Access Compliance Report

Public Rights-of-Way

Intersection ID: 43735	Main Street: BELMONT_WALK_WY	Cross Street: BRIDGEVIEW_LN	Location: SE
ADA ID: 3704FD223AB9	Ramp Type: PerpDiag	Initial Pass/Fail: Fail	Overall Compliance: No
		Severity Score: 22.5

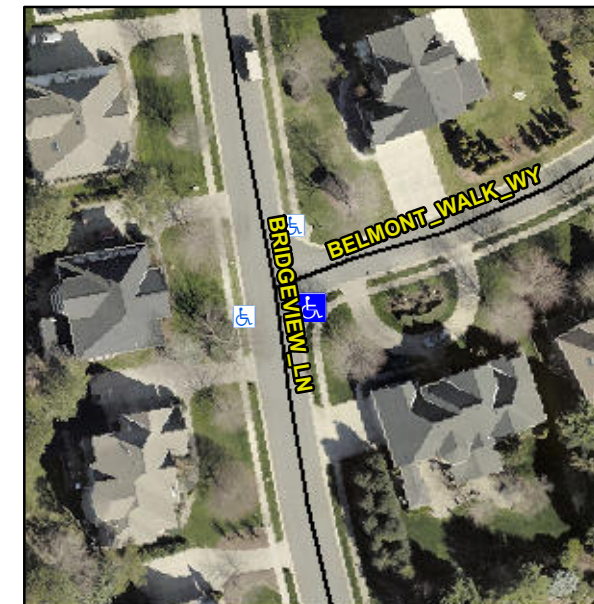
Not Found, R304.5.1, R304.2.2, R304.5.3

Compliance	Description	Data	Compliance	Description	Data
N/A	Ramp Length (in)	48.0	No	Ramp Slope (%)	8.4
No	Ramp Width (in)	43.0	No	Ramp XSlope (%)	3.9
N/A	Flare Type LT	N/A	N/A	Flare Type RT	N/A
N/A	Flare Slope LT (%)	N/A	N/A	Flare Slope RT (%)	N/A
N/A	Flare Traversable LT?	N/A	N/A	Flare Traversable RT?	N/A
N/A	Landing Length (in)	N/A	N/A	DWS Provided?	N/A
N/A	Landing Width (in)	N/A	N/A	DWS Contrast?	N/A
N/A	Landing Slope (%)	N/A	N/A	DWS Length (in)	N/A
N/A	Landing X Slope (%)	N/A	N/A	DWS Full Width?	N/A
N/A	Landing Curb? (Y/N)	N/A	N/A	DWS Offset (in)	N/A
N/A	Shared Landing?	N/A			
N/A	Gutter Ponding?	N/A	N/A	Gutter Slope (%)	N/A
N/A	Gutter Lip Ht (in)	N/A	N/A	Gutter X Slope (%)	N/A
N/A	Painted X Walk1?	No	N/A	Painted X Walk2?	No
	X Walk 1 Direction	To N		X Walk 2 Direction	To W
N/A	X Walk 1 Width (in)	N/A	N/A	X Walk 2 Width (in)	N/A
	X Walk 1 Slope (%)	3.3		X Walk 2 Slope (%)	1.5
	X Walk 1 X Slope (%)	0.6		X Walk 2 X Slope (%)	3.1

Remove & Replace Curb Ramp With Two New Directional Ramps or Equivalent.
